## ORIGINATION FORM

### Proposed Revisions to a Standard Plans Index (Please provide all information — Incomplete forms will be returned)

Index Number: 102-625

Index Title: Temporary Road Closure - 5 Minutes or Less

INDEX  
102-625

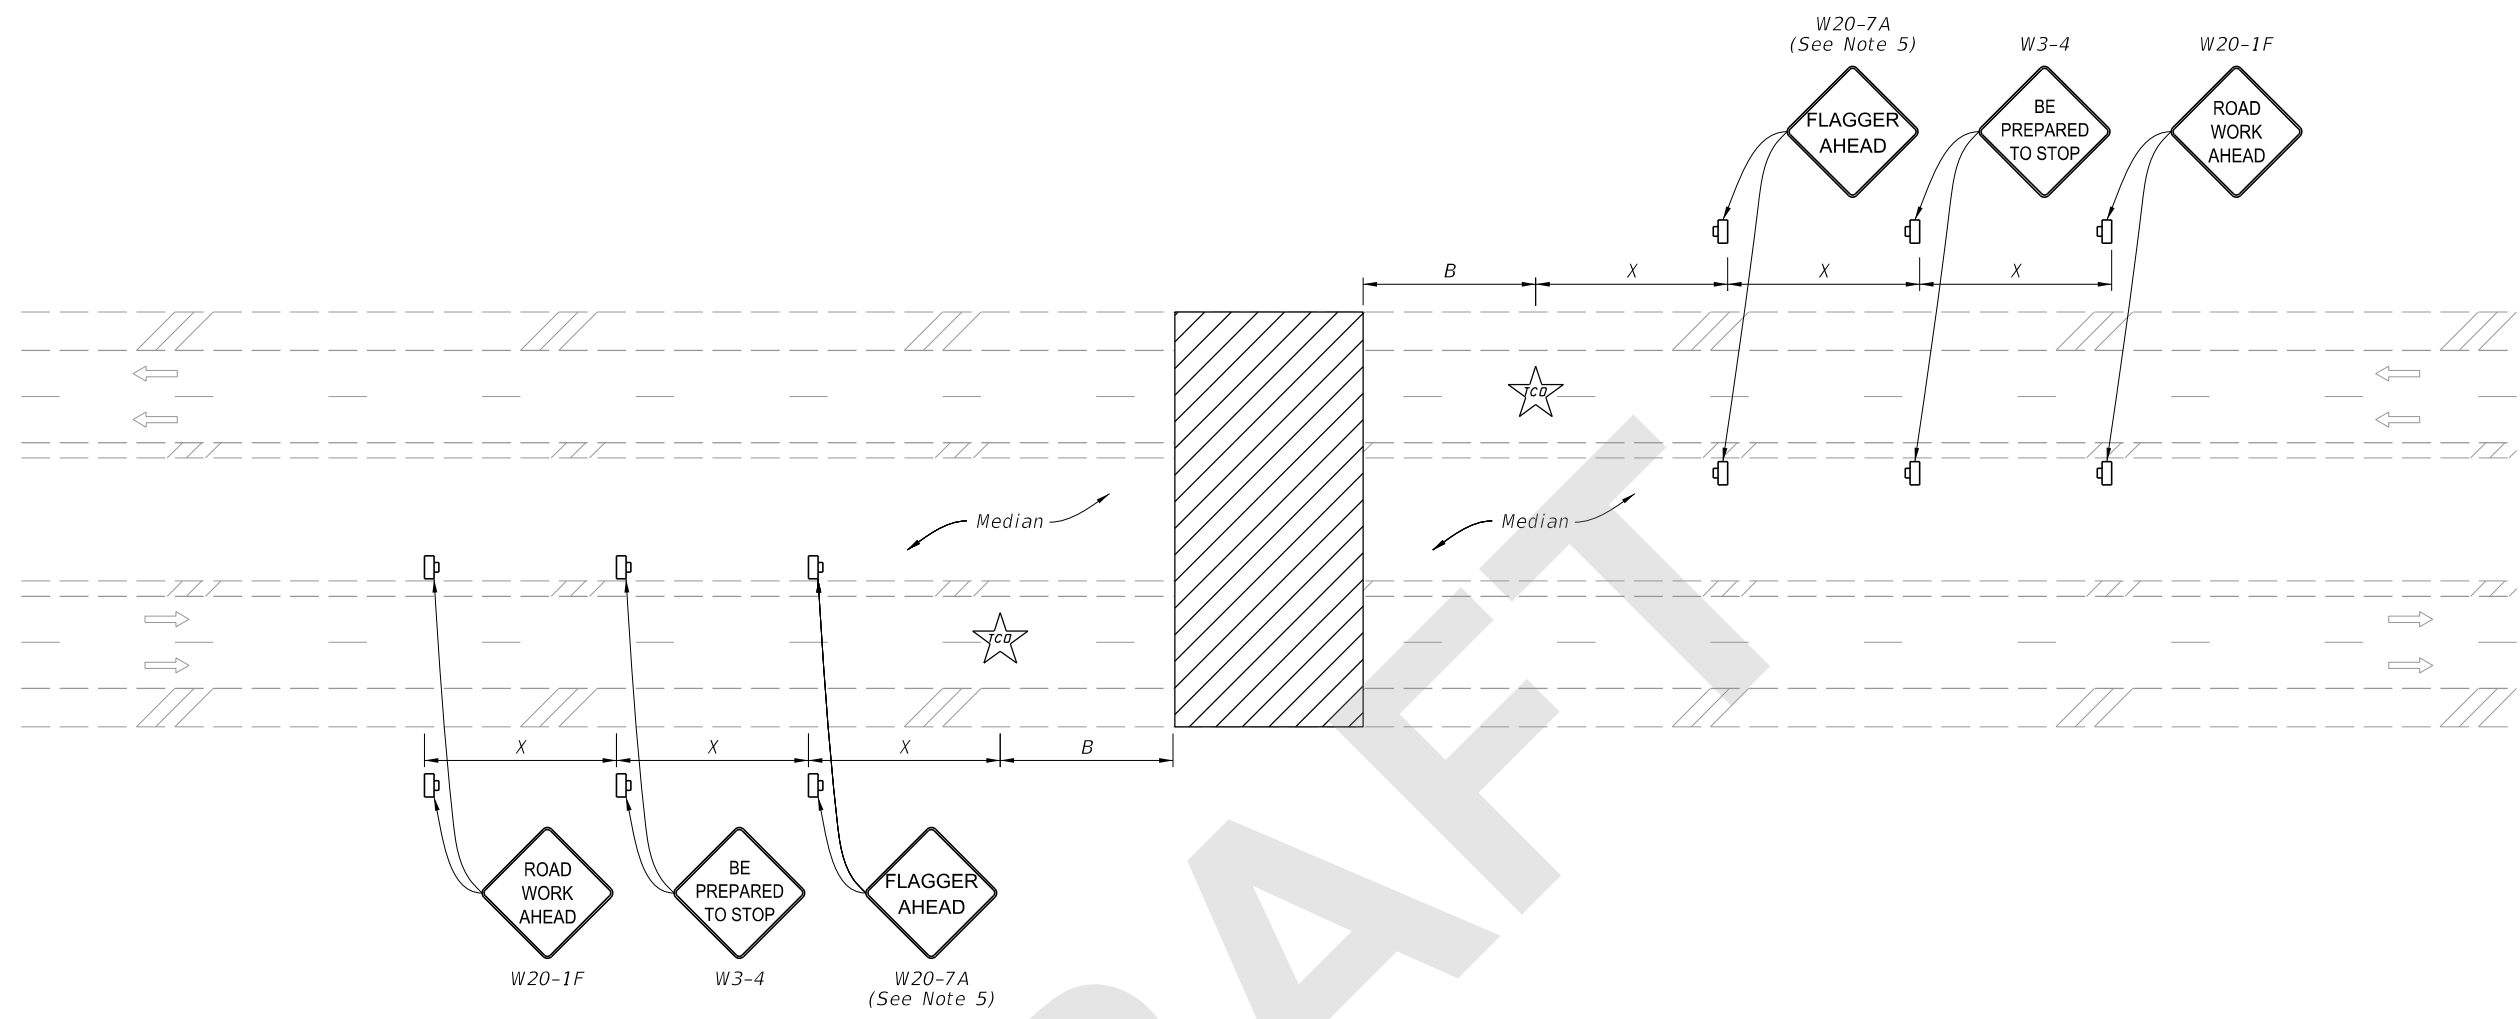
Sheet 1: Revised and Consolidated Details; Revised Notes; Deleted 'Buffer Space' and 'Distance Between Signs' Tables (Moved to 102-600); Deleted Conditions; Renamed Index.

DELETED - CONSOLIDATED AND MOVED TO 102-600

REVISED AND CONSOLIDATED DETAILS

REVISED NOTES

1. This Index applies to two-lane, two-way and multilane roadways, except limited access facilities, with temporary daytime roadway closures of 5 minutes or less.
2. B=Buffer Length  
X=Work Zone Sign Distance  
See Index 102-600 for "B" and "X" values.
3. For Two-Lane Roadways, a Flagger may substitute the traffic control office with approval of the Engineer.
4. Traffic volume or complexity of the roadway may dictate additional signs, devices or traffic control officers.
5. Optionally, use "Flagger Ahead" sign with symbol (W20-7) instead of "Flagger Ahead" sign with text (W20-7A).
6. Dual Signs are required for divided roadways only.
